Response to CEDD's comments (Planning Application No. A/HSK/579) - 25 February 2026

<p>Project 項目名稱:</p> <p>Proposed temporary warehouse for storage of construction material, plastic, machinery, spare part and ancillary packaging workshop for a period of 3 years at Lot No. 23 RP (Part), 28 RP (Part), 30 RP (Part), 43 (Part), 193, 194 (Part), 195 (Part) and 196 (Part) in D.D. 128 and adjoining government land, Ha Tsuen, Yuen Long, N.T.</p>	<p>Drawing Title 圖目:</p> <p>Location Plan for Application Site with Existing Features</p> <p>Drawing No. 圖號:</p> <p>Figure 3</p>	<p>Remarks 備註:</p> <p>→ Vehicular access leading from Deep Bay Road</p> <p>Section mark</p> <p>Scale 比例:</p> <p>1:1000 320,000.00</p>
--	--	---

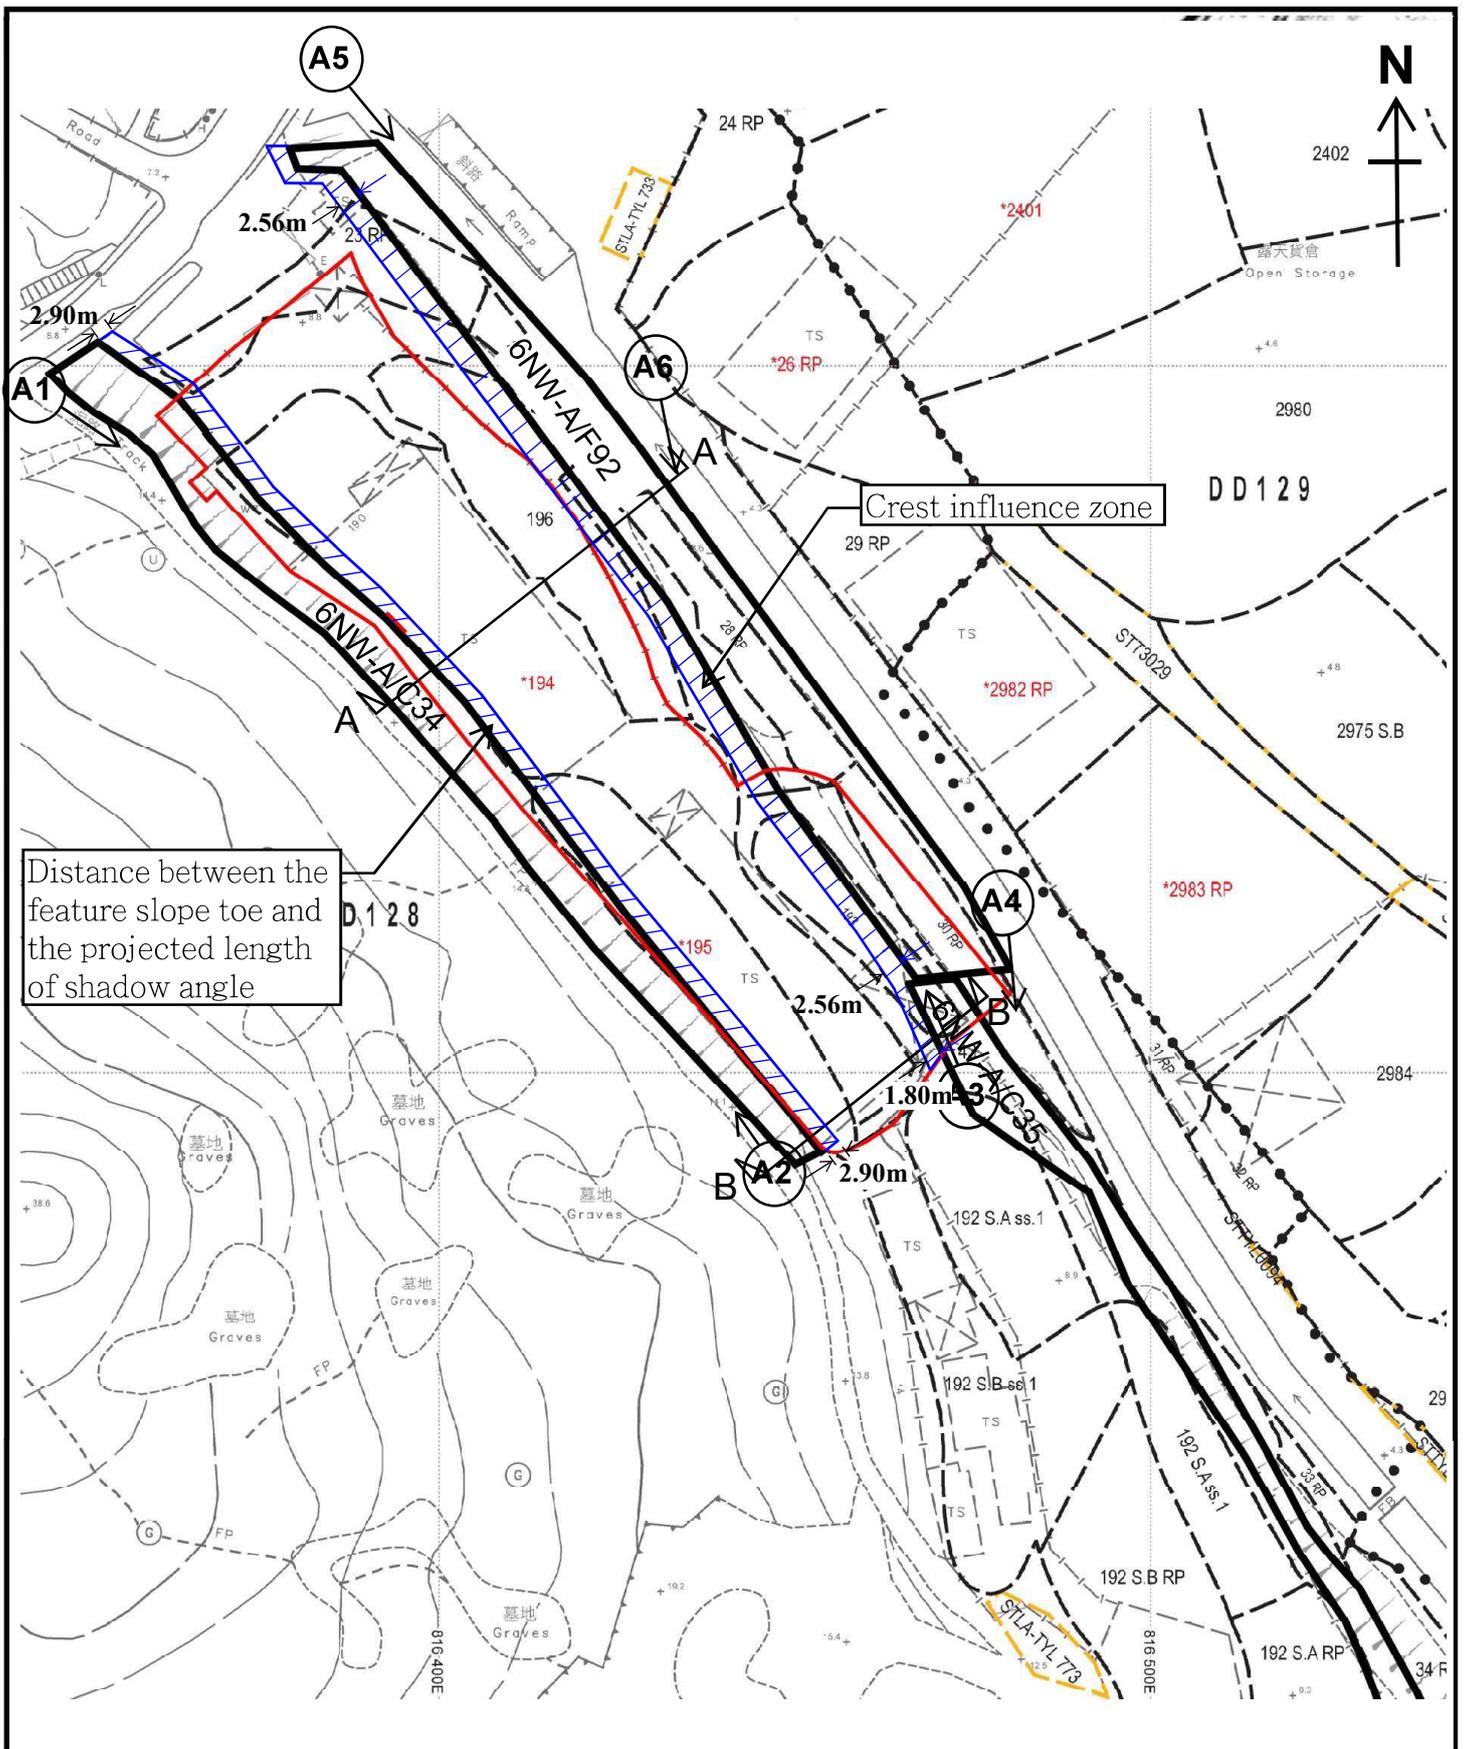
<p>The Geotechnical Engineering Office noted the R-to-C. However, the applicant has not addressed to our previous comments. No assessment has been carried out to assess and substantiate if the failure of the existing features (i.e. feature nos. 6NW-A/C34, 6NW-A/F92 and the northern portion of feature no. 6NW-A/C35) would affect the proposed development and whether slope upgrading works would be required (or inclusion of "No-build zone") for the proposed development.</p>	<p>As declared by the applicant, the Structure 2, 3 and 4 are the existing structures and have been built over 15 years. Please note that no site office will be provided within the application site. Also, it is not for site office/residential use.</p> <p>In accordance with GEO Technical Guidance Note No. 15, the crest influence zone for feature no. 6NW-A/C35 and 6NW-A/F92 is 1.8m and 2.56m respectively, and the distance between the slope toe of feature no. 6NW-A/C34 and the projected length of shadow angle is 2.9m. The updated Proposed Layout Plan and Figure 3 are enclosed for easy reference.</p>
